# Work Order ID 119202

Item ID: D2731-3RG **D2731-3**  
 Revision ID: **B119202**  
 Item Name: Mounting Lug  
 Start Date: 5/14/14 Start Qty: 108.00 **\*108\***  
 Required Date: 6/04/14 Req'd Qty: 108.00 **\*108\***  
 Reference:

DRAWING NO. D2731	TITLE MOUNTING LUG	REV. C	DART AEROSPACE USA, INC ENGINEERING ORDER		D.E.O. NO. D2731-C-1	SHEET NO. SHEET 1 OF 1	SCALE NTS
DRAWN <i>qp</i>	CHECKED <i>Sc</i>	MFG. APPR. <i>M</i>		APPROVED <i>AD</i>		DE APPR. <i>#</i>	
DATE 11.05.02	DATE 11.05.09	DATE 11.05.09		DATE 11.05.09		DATE 11.05.09

**D2731-7 MOUNTING LUG**

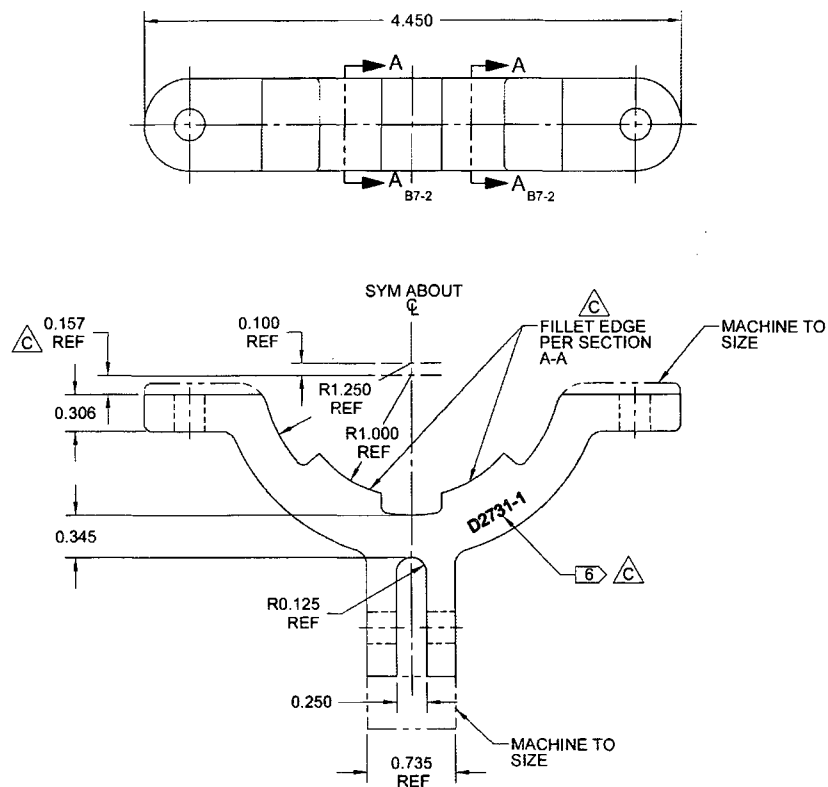
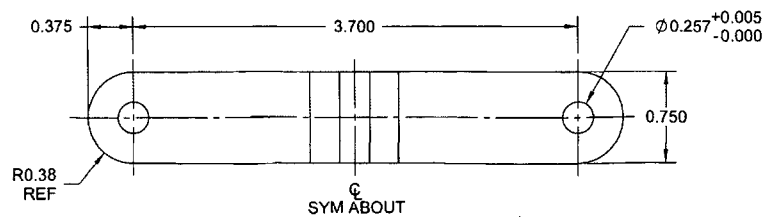
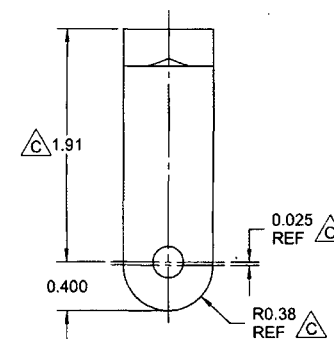
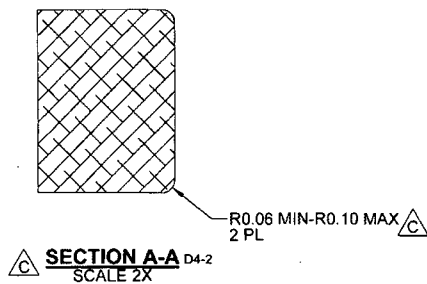
C	REDRAWN IN SOLIDWORKS TO CURRENT DESIGN STANDARDS. REFER TO SECTION A-A, B-B, C-C & D-D FILLET ADDED TO PREVENT CHAFING OF RUBBER CUSHION ON INSTALLATION.	AJS	09.01.19
B	REVISED DIMENSIONS	KE	99.07.06
A	NEW ISSUE	KE	98.05.13
REV.	DESCRIPTION	BY	DATE
DESIGN	KE	<b>DART AEROSPACE USA, INC.</b>	
DRAWN	AJS	PORT HADLOCK, WA	
CHECKED		DRAWING NO.	REV. C
MFG. APPR.		<b>D2731</b>	SHEET 1 OF 5
APPROVED		TITLE	SCALE
DE APPR.		<b>MOUNTING LUG</b>	NTS
DATE	09.01.19	<small>COPYRIGHT © 1986 BY DART AEROSPACE USA, INC. THIS DOCUMENT IS PRIVATE AND CONFIDENTIAL AND IS SUPPLIED ON THE EXPRESS CONDITION THAT IT IS NOT TO BE USED FOR ANY PURPOSE OR COPIED OR COMMUNICATED TO ANY OTHER PERSON WITHOUT WRITTEN PERMISSION FROM DART AEROSPACE USA, INC.</small>

**D2731-1RG MOUNTING LUG (SHOWN)**  
**D2731-3RG/-5RG/-7RG MOUNTING LUGS (SIMILAR)**

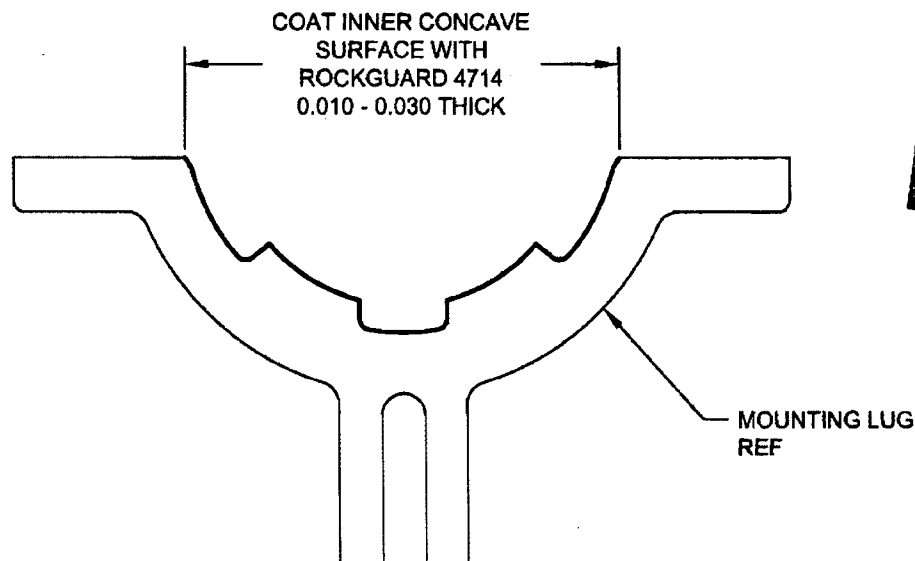
ADD D2731-xRG OPTION

D2731-xRG MOUNTING LUGS ARE IDENTICAL TO D2731-x MOUNTING LUGS, HOWEVER AFTER FINISH, COAT INNER CONCAVE SURFACE WITH "PLUS ONE ROCKGUARD 4714" AS SHOWN BELOW.
